Septic Repair

ON-SITE SEWAGE DISPOSAL SYSTEM
HOWARD COUNTY HEALTH DEPARTMENT
BUREAU OF ENVIRONMENTAL HEALTH

P 536651

ADDRESS: 8494 Reservoir Road PROPERTY OWNER: Kevin and Barbara Hiden

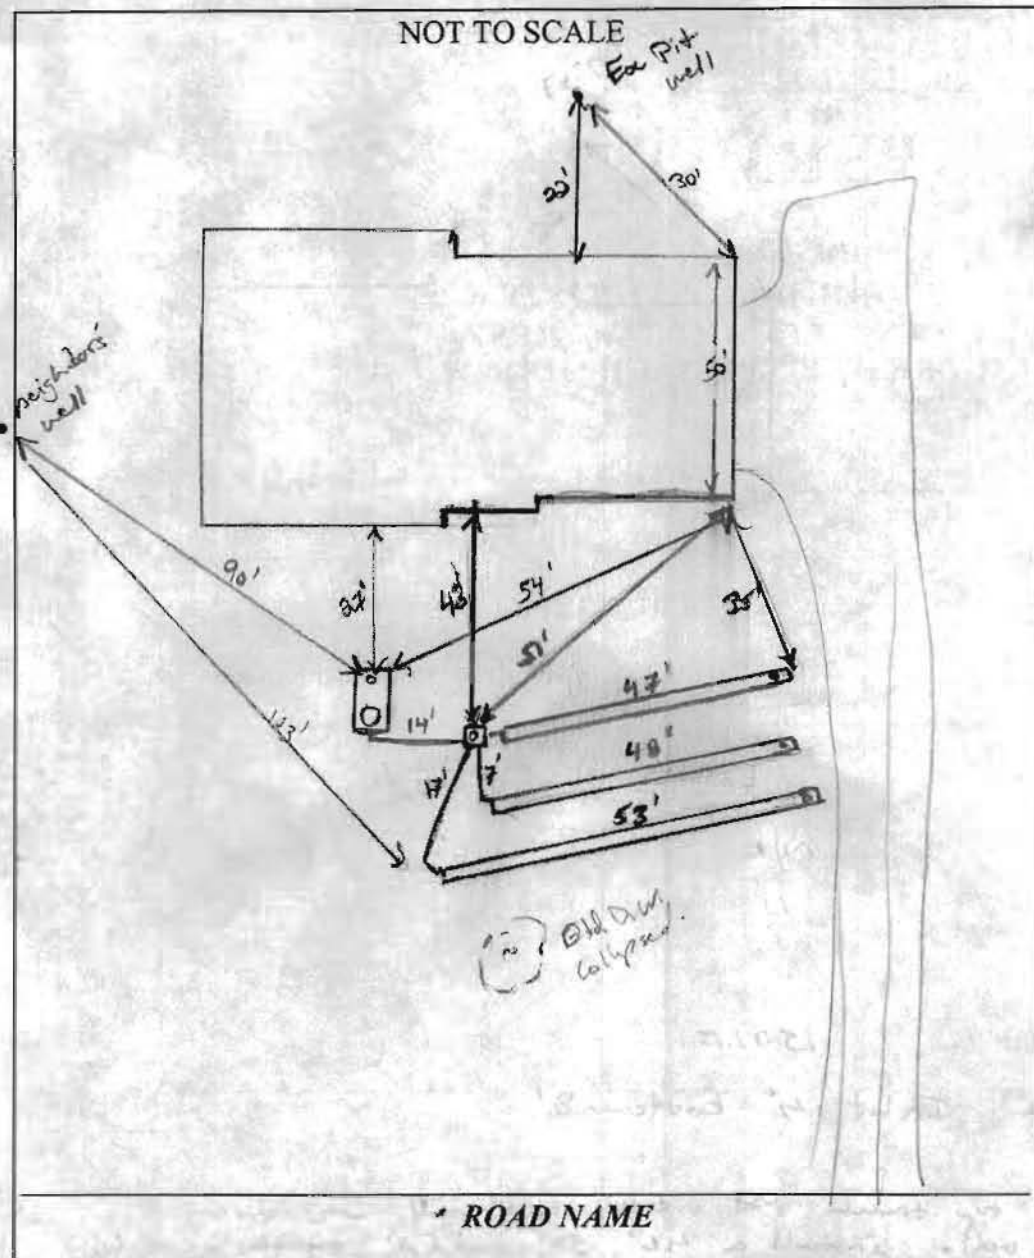
TRENCHES:	<u>2' wide Inlet 4' bottom 8'</u>
LOCATION:	<u>Install top trench west outside 100' well away from neighbors well. Install a 46', 50' and 52' trenches on contour as pointed out in field.</u>
PURPOSE:	<u>Pump & collapse Ex. D.W. manhole needed on ST.</u>

12/13/11 Install a 46' trench ~30' from house on constant staying out of well area. A 50' trench and a 52' trench will follow below top trench. Ex DW must be pumped and collapsed. (Kew)

INSTALLATION: 12/14/11 manhole riser added to tank w/ new outlet baffle filter. Top trench dug no stone. OK to continue (Kew)
12/15/11 System complete. Explained to homeowner that upgrading pit well might be a good idea. Make sure to have well tested annually. OK to cover all work.
